Rapiscan Secure 1000

R-0646-1 Addendum (Documentation Errors)

Product Name	Secure 1000SP (Single Pose)
Serial Number	S51039008
Radiation Emission Measurement	Radiation Survey Dated: 12/01/2010
RSO Initials	[REDACTED]

2. Radiation Leakage Measurement: Survey Table. 2

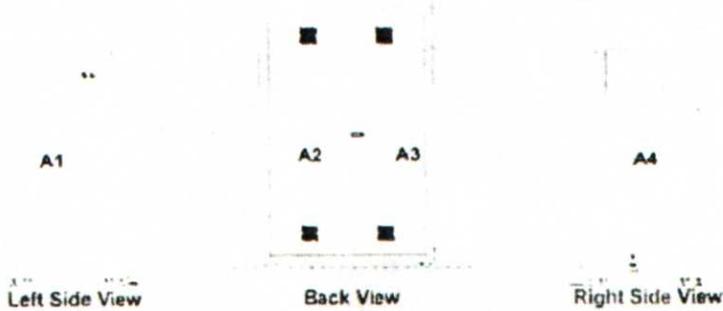
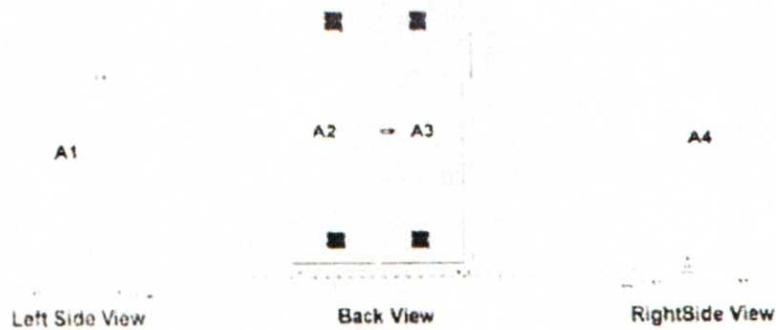
1. Time of day not noted.
2. TABLES 2 and 3: Incorrect presentation of data in Column 3 for Measured Exposure. Indicated values are .1 uRem. The correct value should be 1 uRem.
3. TABLES 2 and 3: Incorrect presentation of data in Column 6 for Dose Equivalent. Indicated values are .18 uRem. The correct value should be 1.8 uRem.

The service technician should attend refresher training.

The corrected data indicates this system was operating within expected parameters. No re-survey is required for this system.
